**ONSITE SEWAGE DISPOSAL SYSTEM**

**RE:** BAT (LPD) Plan  
Gaither's Chance, Lot 10

ONSITE SEWAGE DISPOSAL SYSTEM DESIGN PLAN

**GAITHER'S CHANCE**  
LOT 10 (5058 Gaithers Chance Drive)  
PLAT NO. 23699

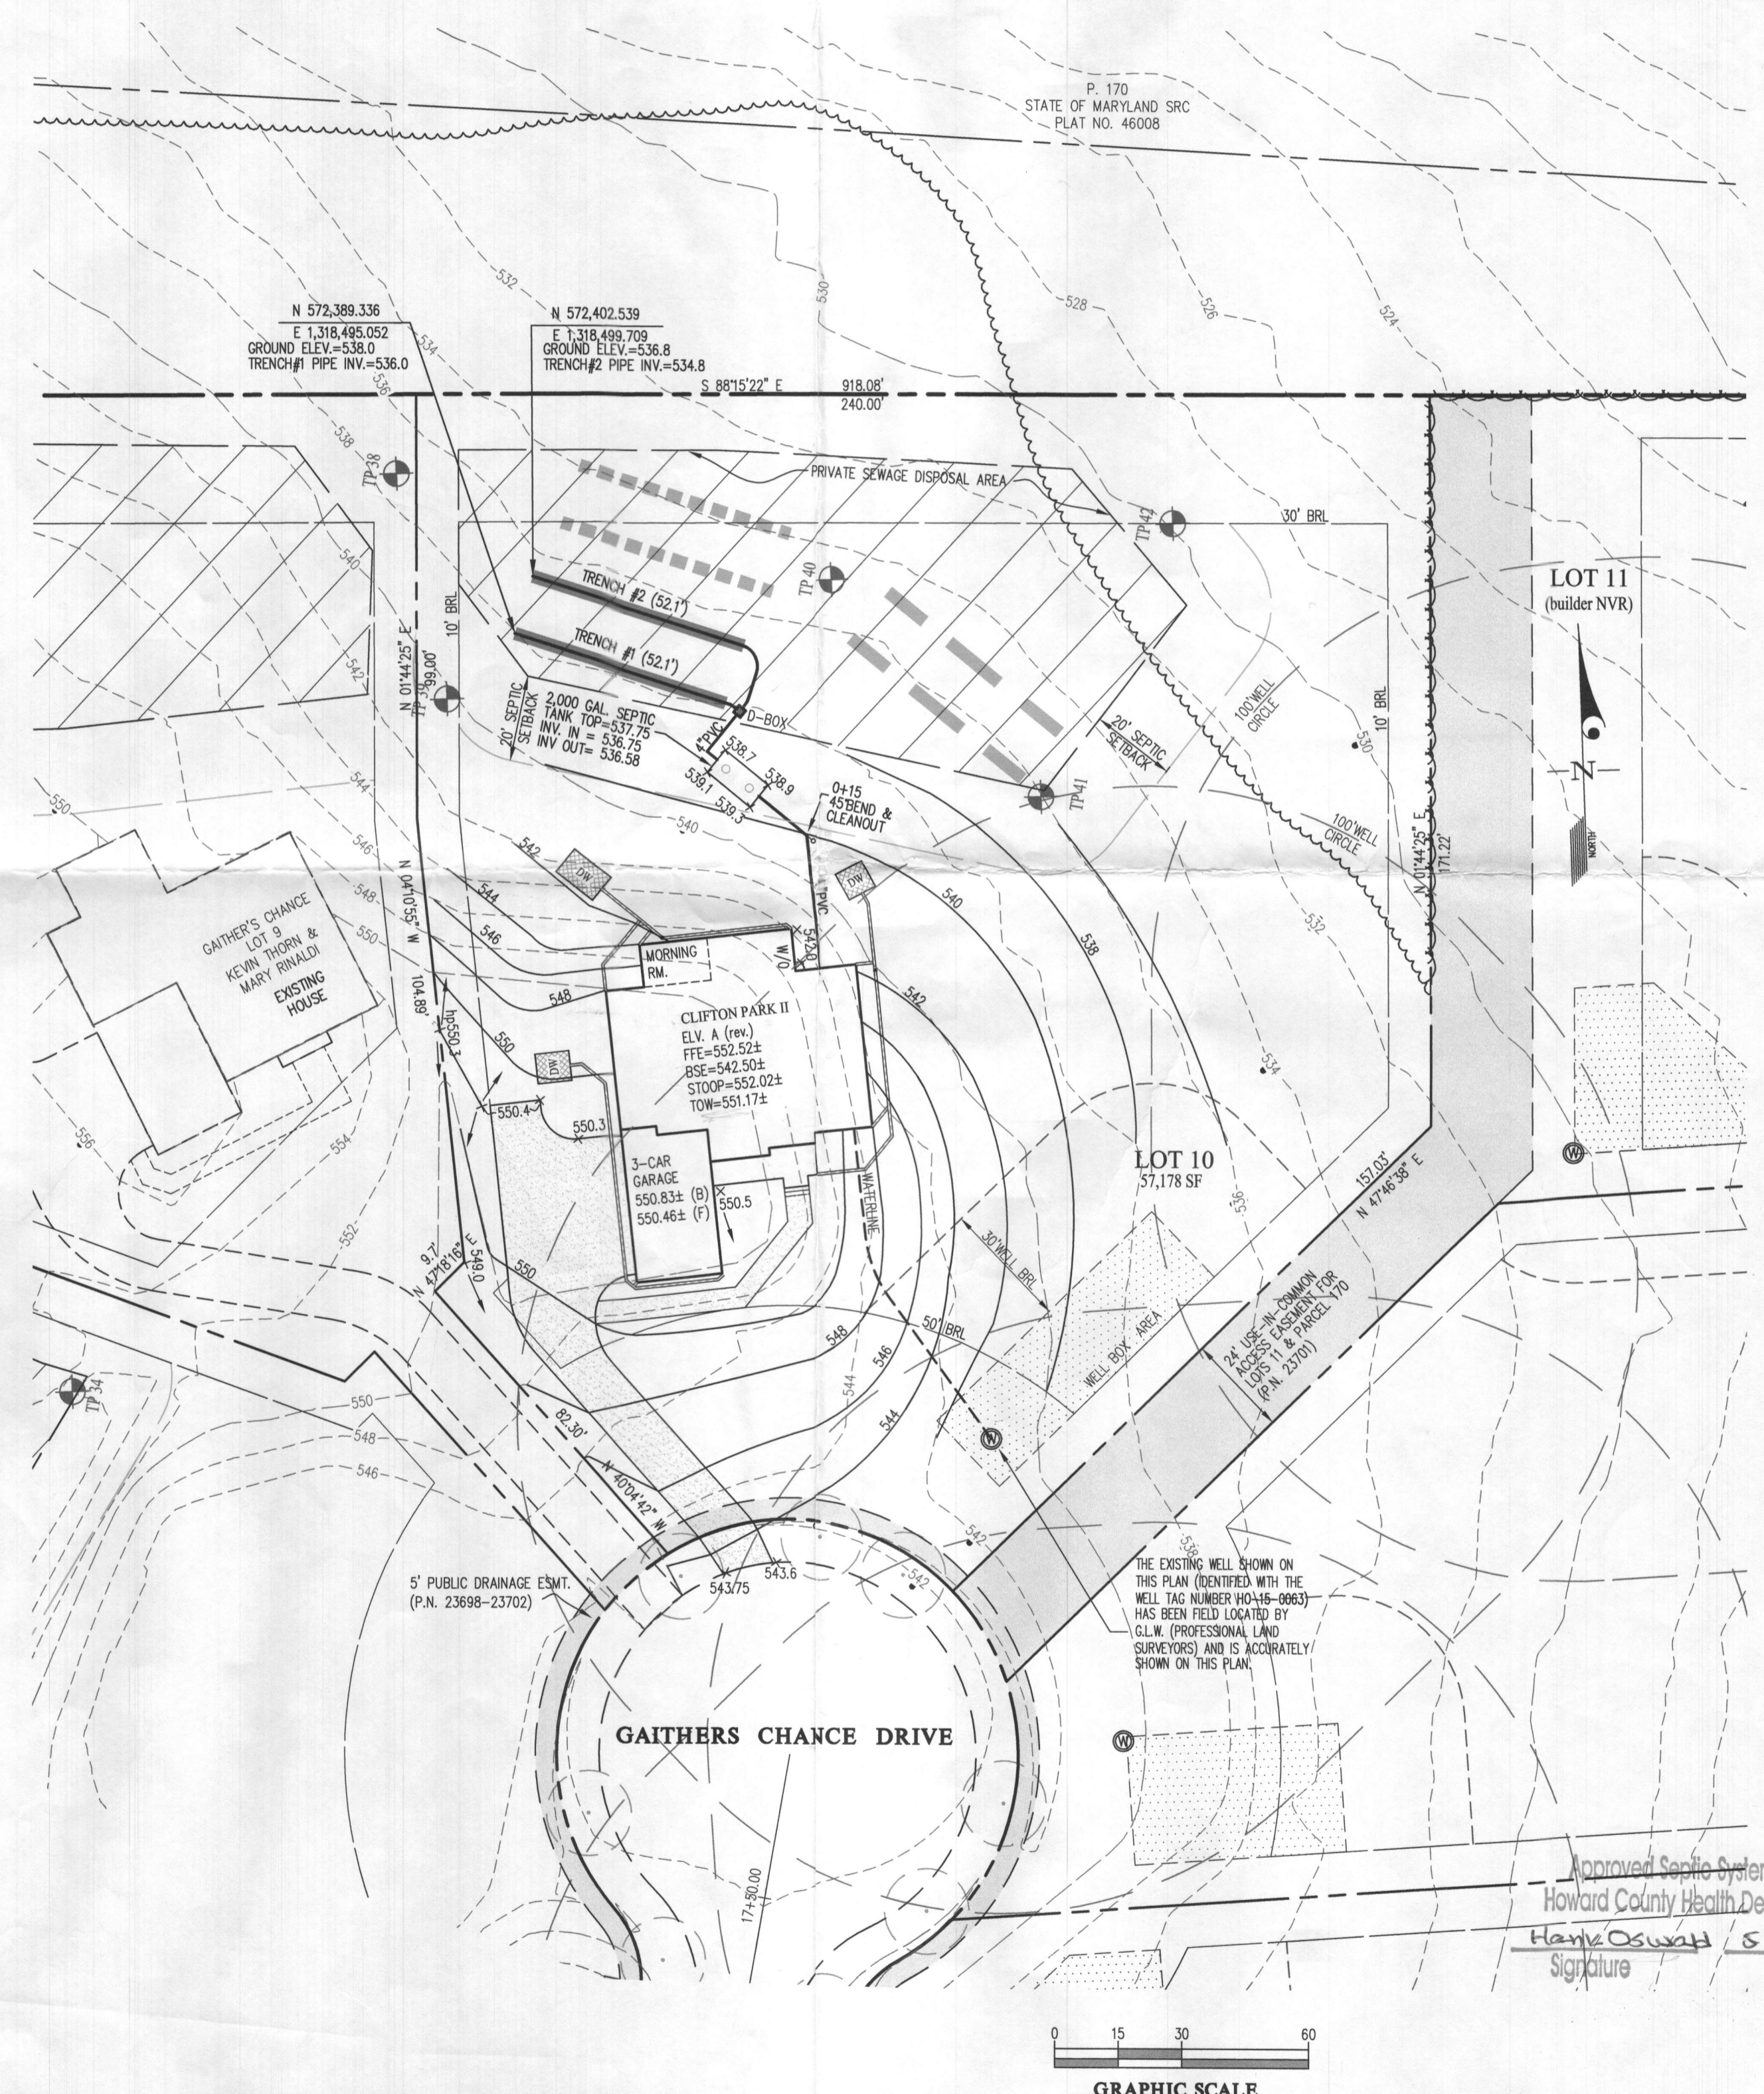
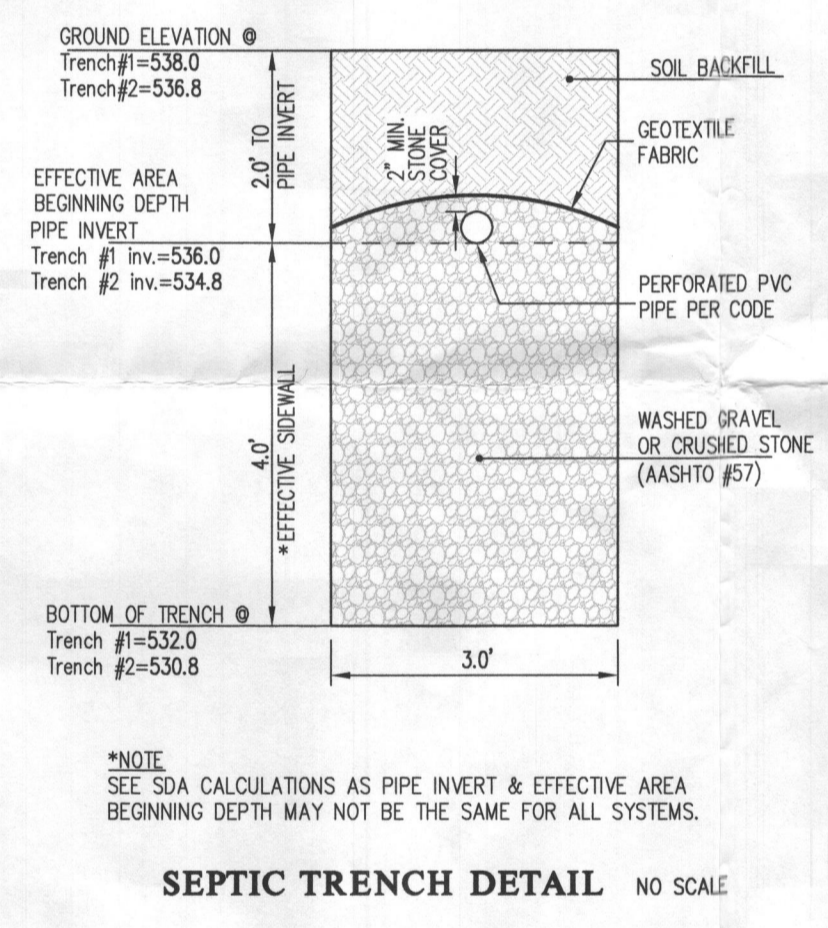
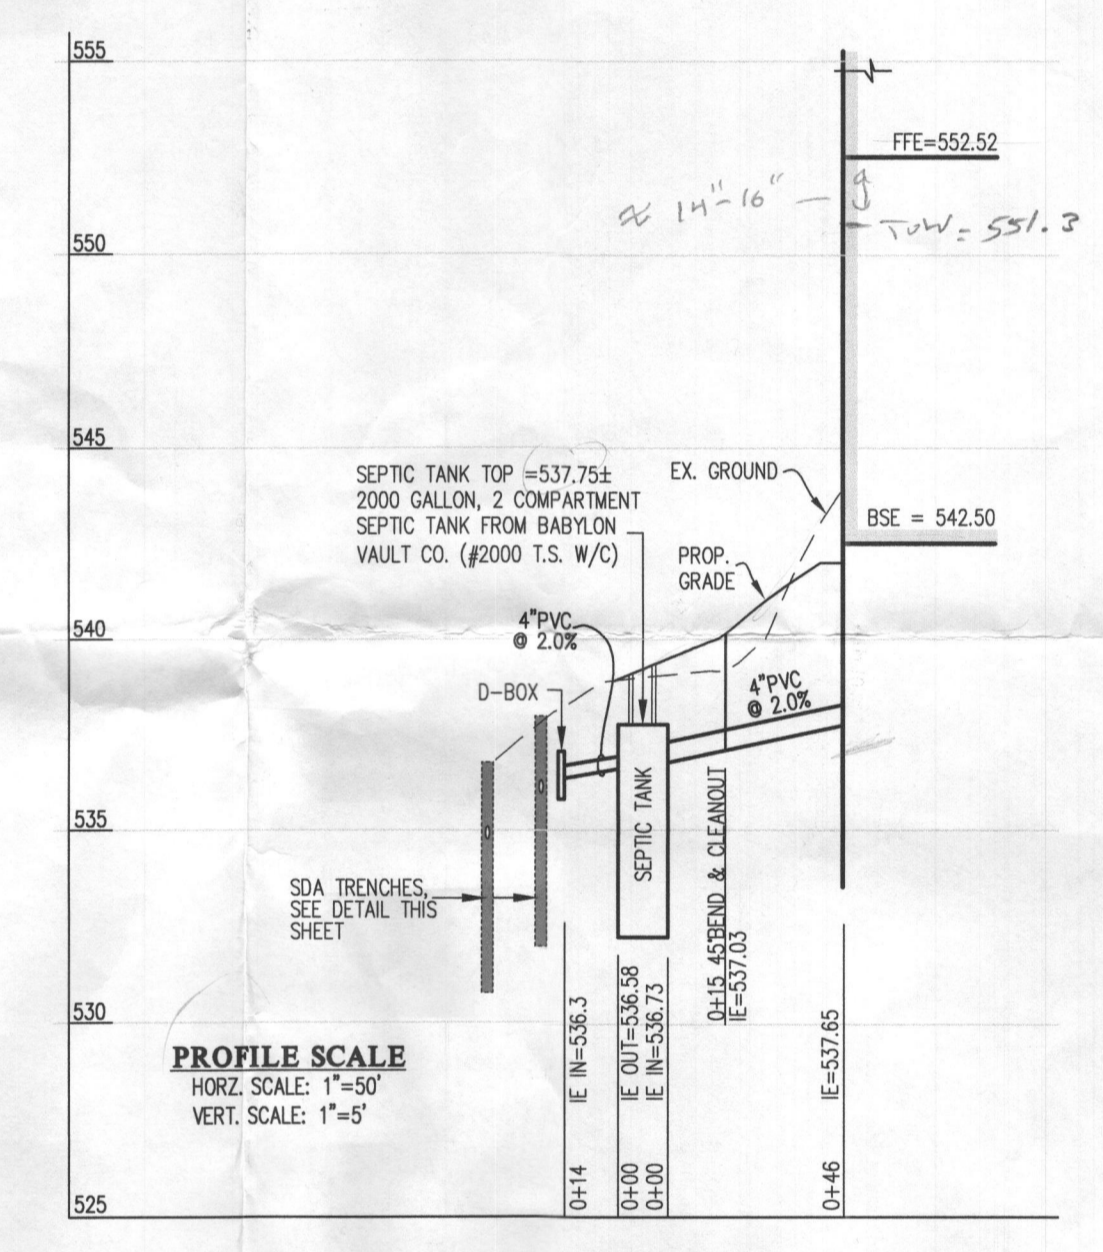
The septic plan for has been reviewed with the following comments:

- 1.) A BAT & LPD design is required on this lot (requires pump tank/chamber).
- 2.) Design septic system distribution trenches to be as shallow as possible (Pressure dosed systems shall have inverts at 18-24" depth unless deeper is required for site conditions).
- 3.) Show trenches on contour.
- 4.) Note: Septic specs included in this response.
